ADDENDUM NO. TWO

PROJECT: Johnson County Recycling Center

PROJECT NUMBER: 23122

DATE OF ADDENDUM: May 27, 2024

A101

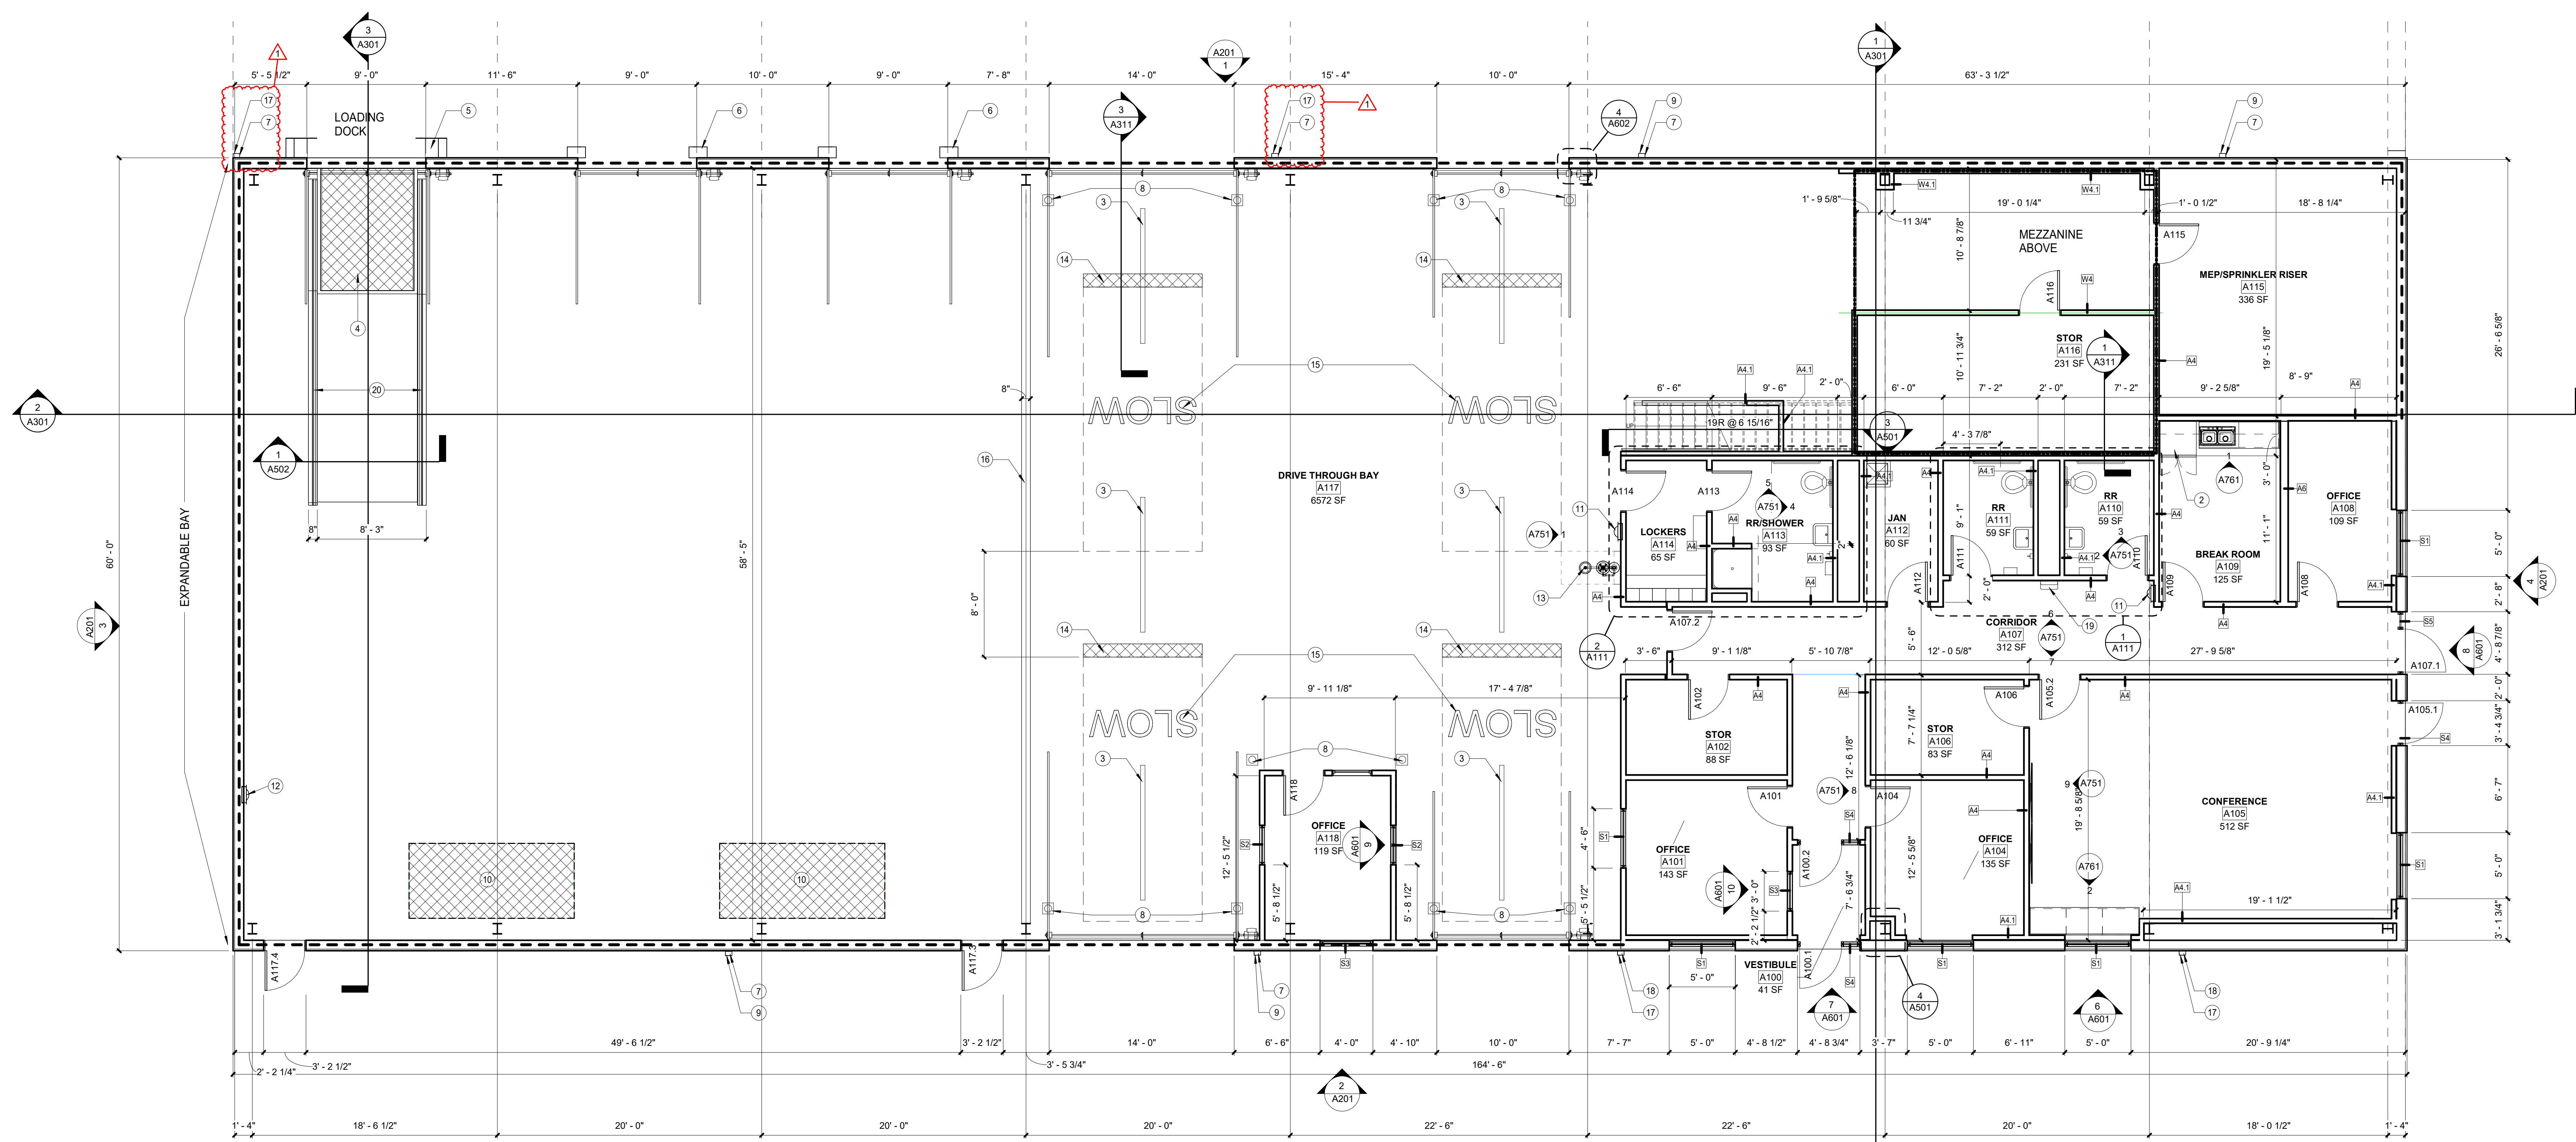
1. Drawing Number: A101
Drawing Title: FLOOR PLAN – FIRST FLOOR
Change:

Adjusted location of the downspouts on the north side

EXTERIOR ELEVATIONS

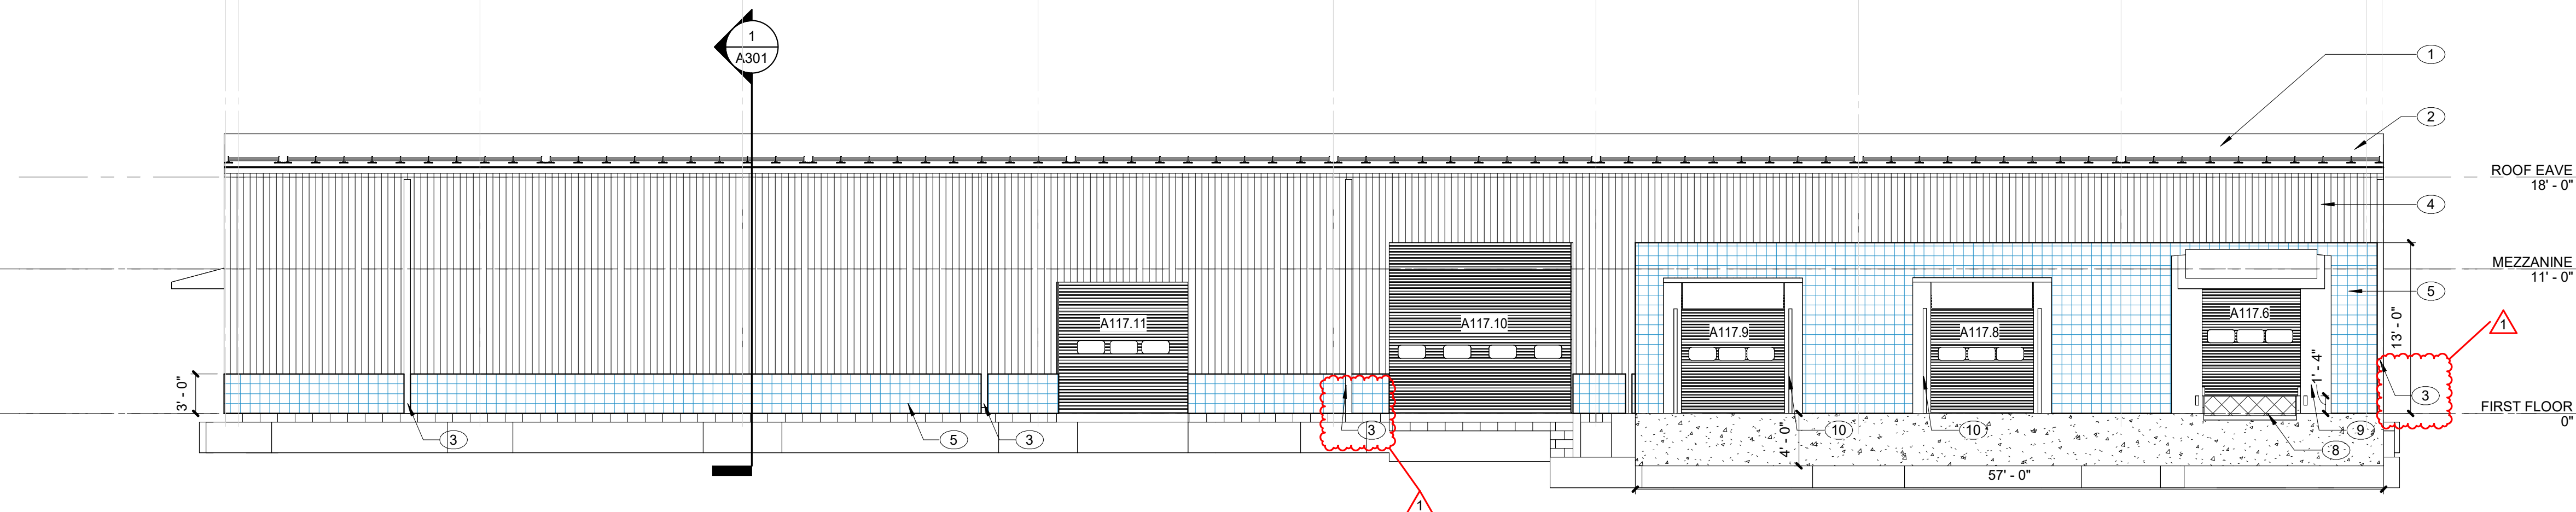
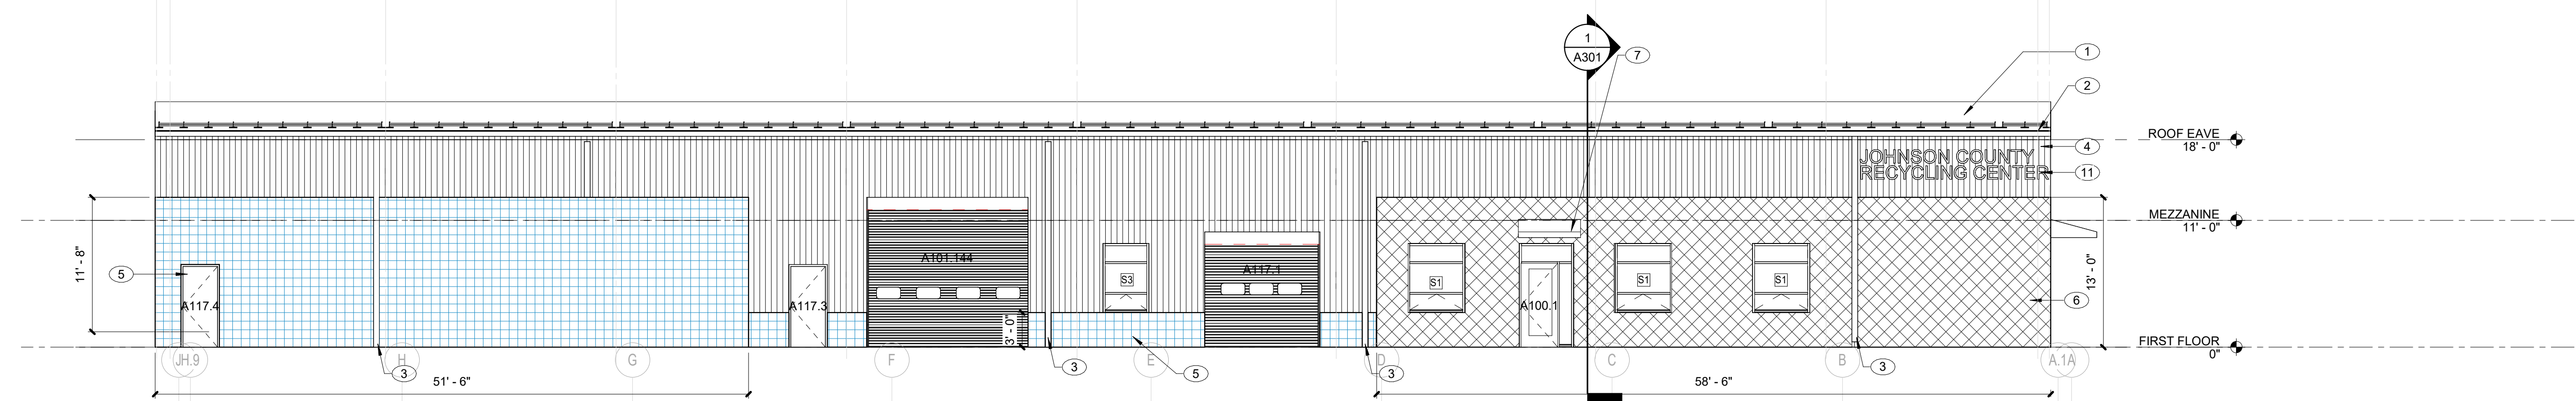
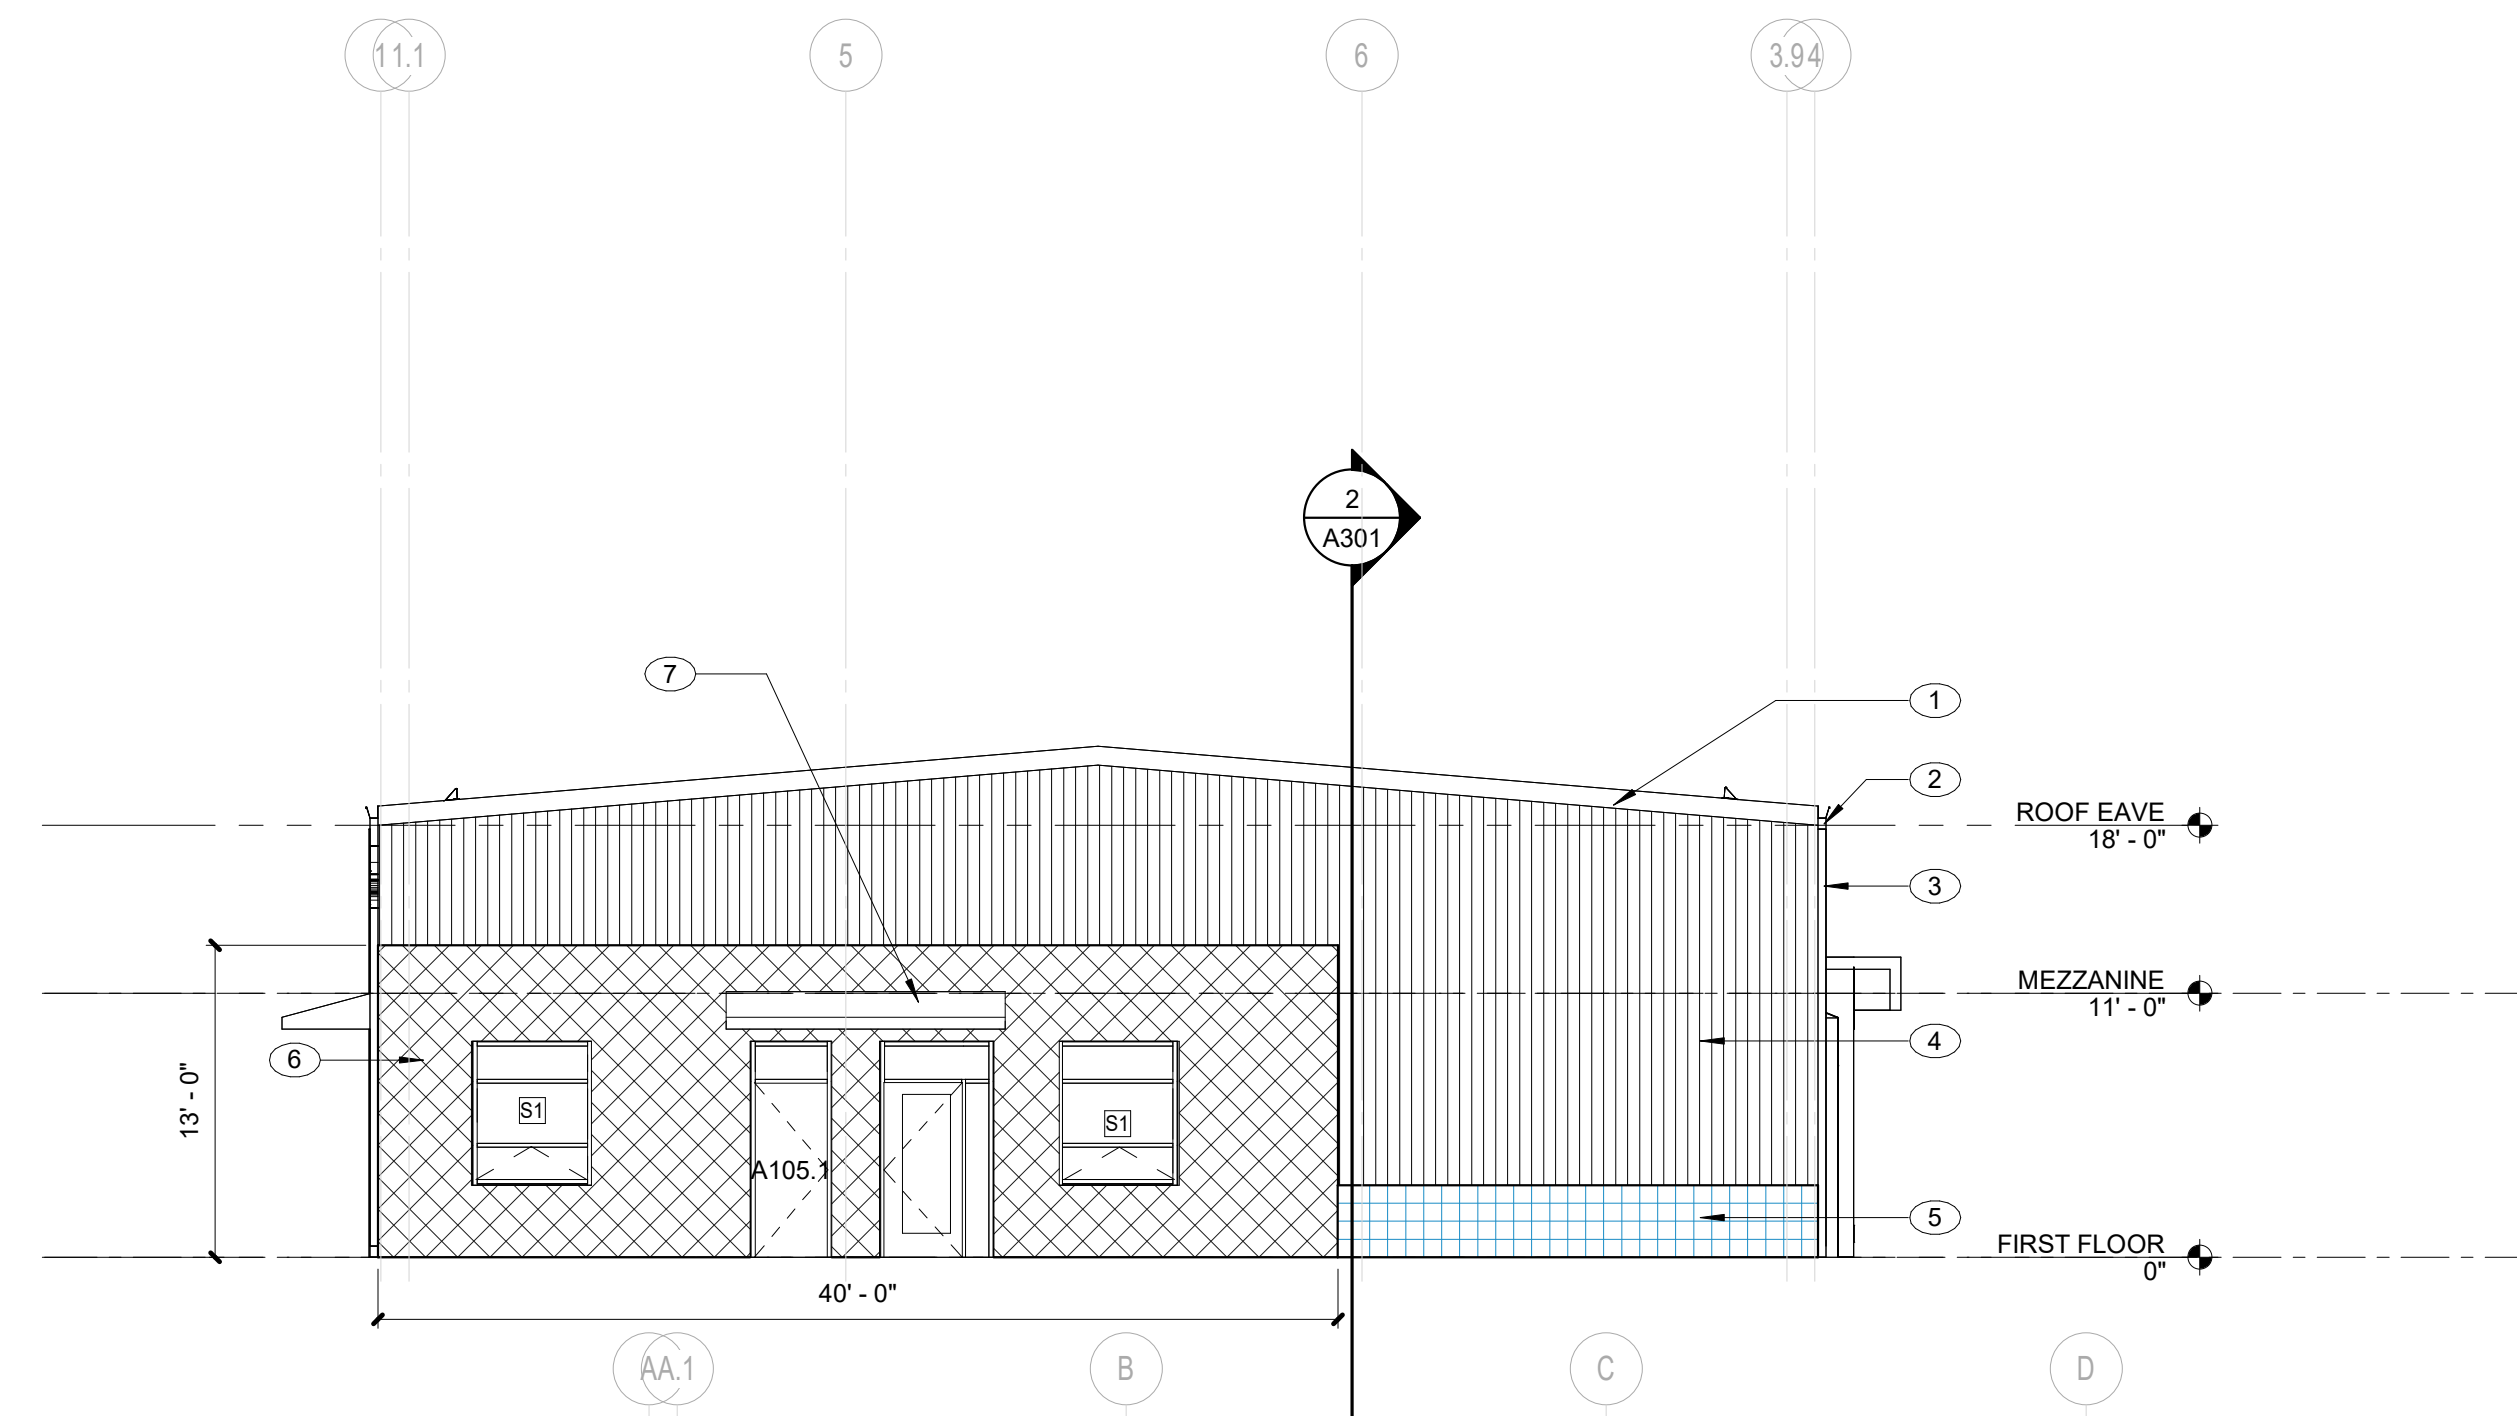
2. Drawing Number: A201
Drawing Title: EXTERIOR ELEVATIONS
Change:

Adjusted location of the downspouts on the north side
